**COMMENTS OF CITIZENS ACTION COALITION, EARTHJUSTICE, INDIANA  
DISTRIBUTED ENERGY ALLIANCE, MICHAEL A. MULLETT, SIERRA CLUB, AND  
VALLEY WATCH ON THE DRAFT REPORT OF THE IURC  
REGARDING 2015-2016 IRPs**

**I. DUKE ENERGY INDIANA’S 2015 IRP**

## II. INDIANA MICHIGAN'S 2015 IRP

# Rockport Generation Chart

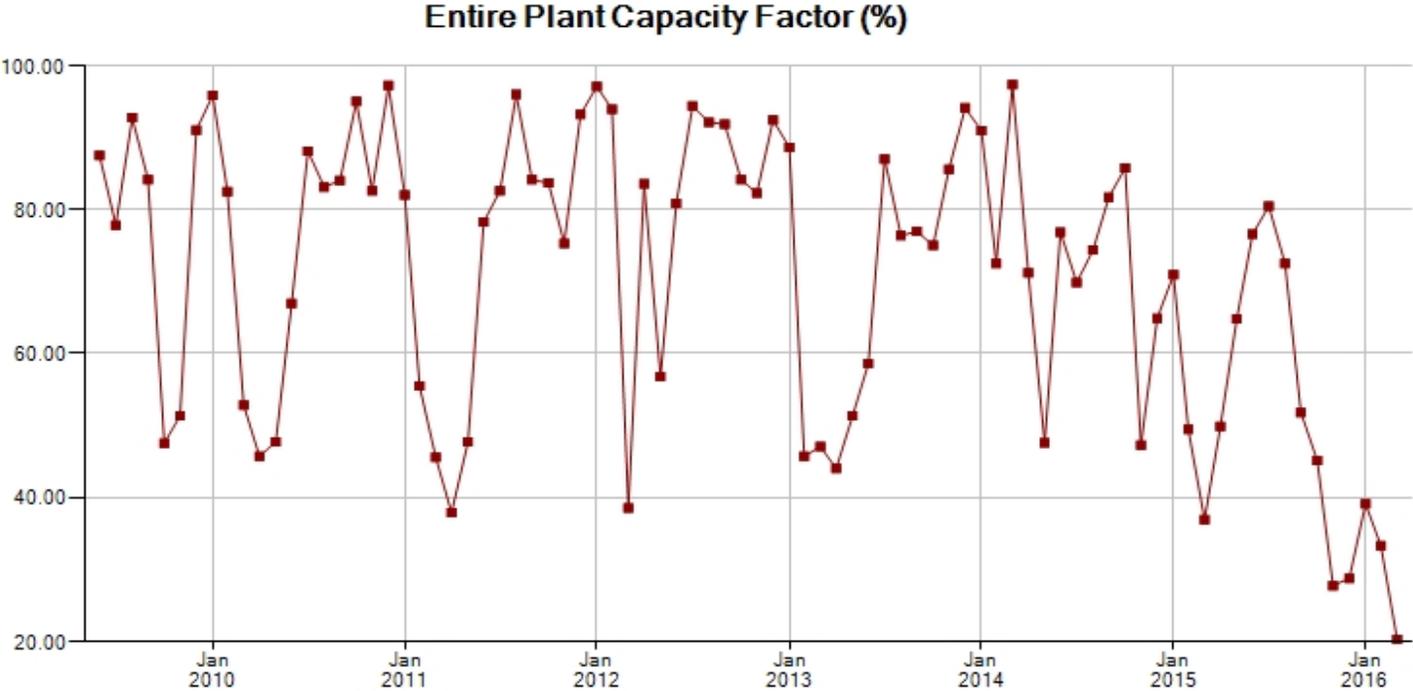
Finally, Joint Commenters are concerned that continued investment in the Rockport and Clifty Creek plants poses severe risks to customers because the plants are already running at lower-than-usual capacity factors due to their apparent inability to compete in the PJM market. For example, as shown in the attached graph and table, Rockport's capacity factor fell below 50 percent in October 2015 and had not exceeded 50 percent as of March 2016, the most recent data available from SNL Financial. Moreover, future market prices do not look favorable to Rockport and Clifty Creek. We respectfully ask that Final Report address the risk of market volatility to I&M customers and the need for I&M to carefully consider large capital expenditures on uncompetitive power plants.
